STATE OF RHODE ISLAND AND PROVIDENCE PLANTATION  
DEPARTMENT OF TRANSPORTATION  
RHODE ISLAND CONTRACT NO.2011-CH-108  
FEDERAL-AID PROJECT NO. FAP Nos: NHSG-RESF(222), NHS-RESF(221)

**Improvements to Route 138**

NOTICE TO PROSPECTIVE BIDDERS

ADDENDUM NO. 1 Prospective bidders and all concerned are hereby notified of the following changes in the Plans, Specifications, Proposal and Distribution of Quantities for this contract. These changes shall be incorporated in the Plans, Specifications, Proposal and Distribution of Quantities, and shall become an integral part of the Contract Documents.

TYPICAL DETAILS 1

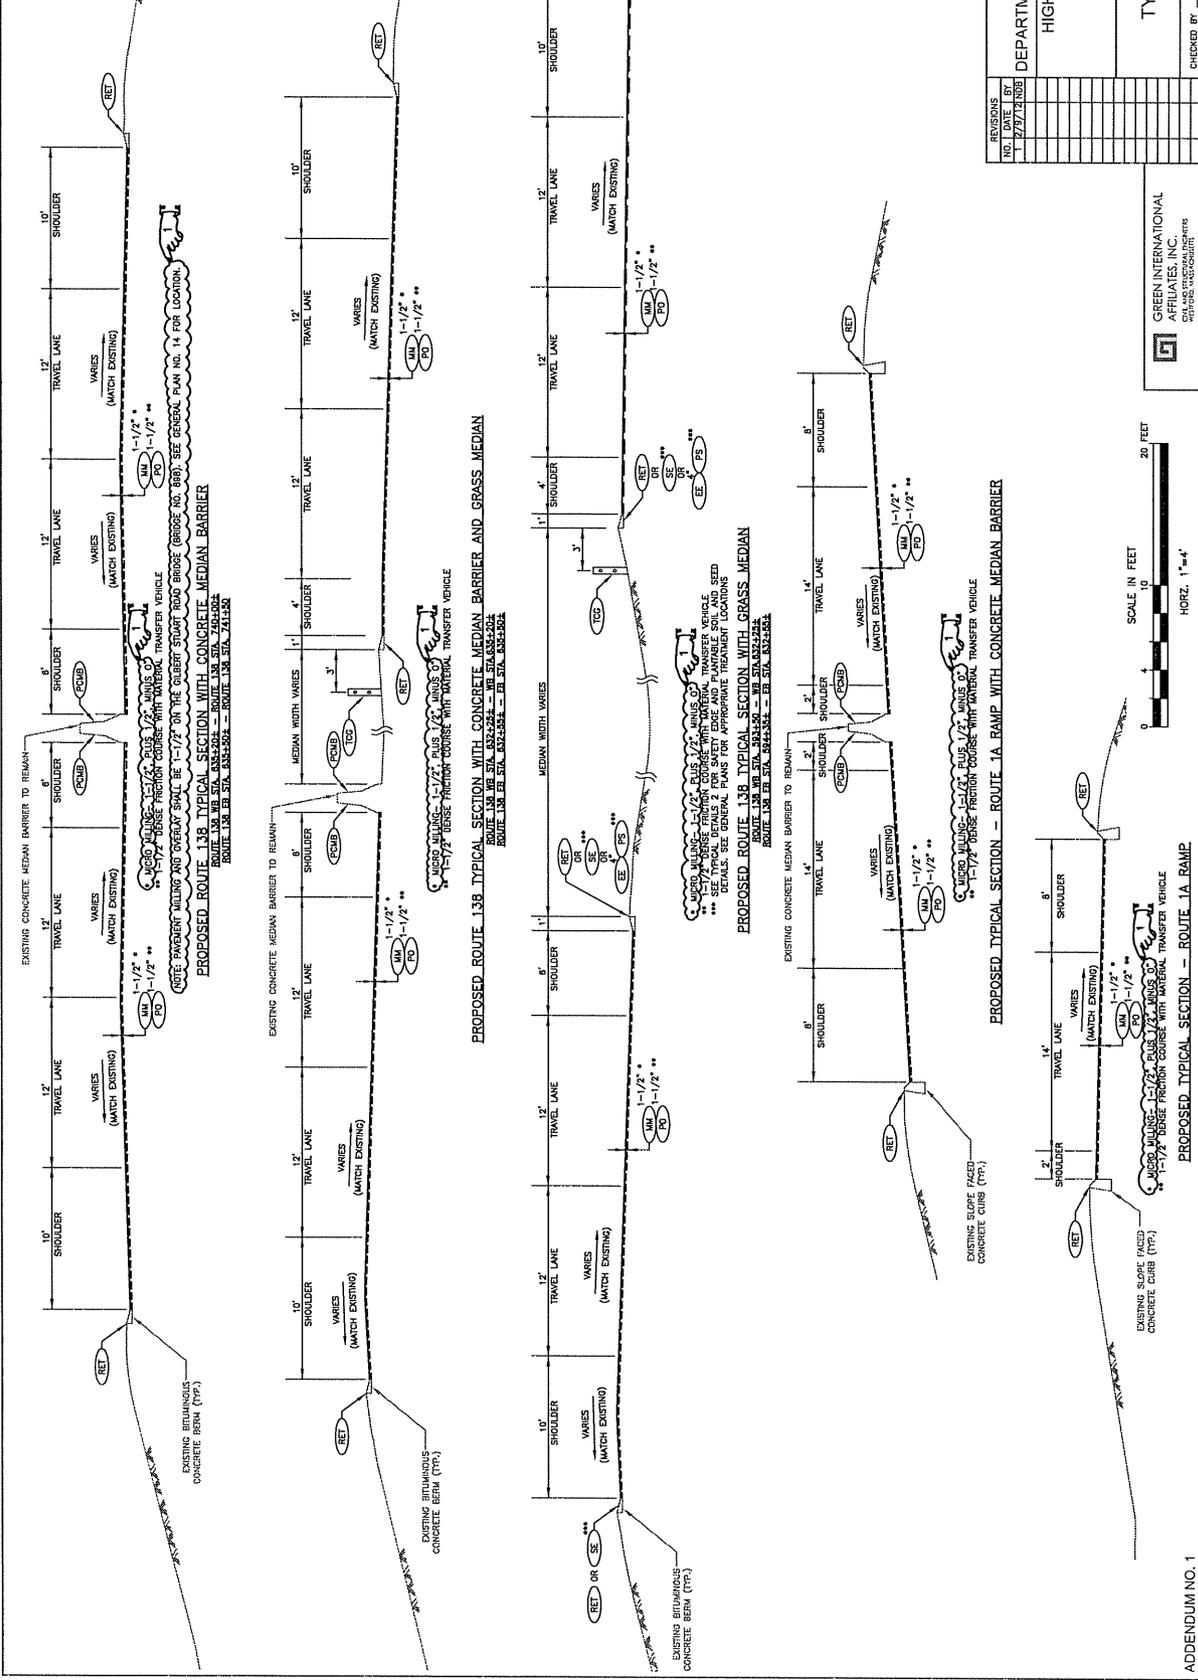
2. Sheet No. 8 Typical Details 1

Delete Sheet No. 8 in its entirety and replace with revised Sheet No. 8 (R-1) attached to this Addendum No. 1. The tolerance for micro milling depth has been added.
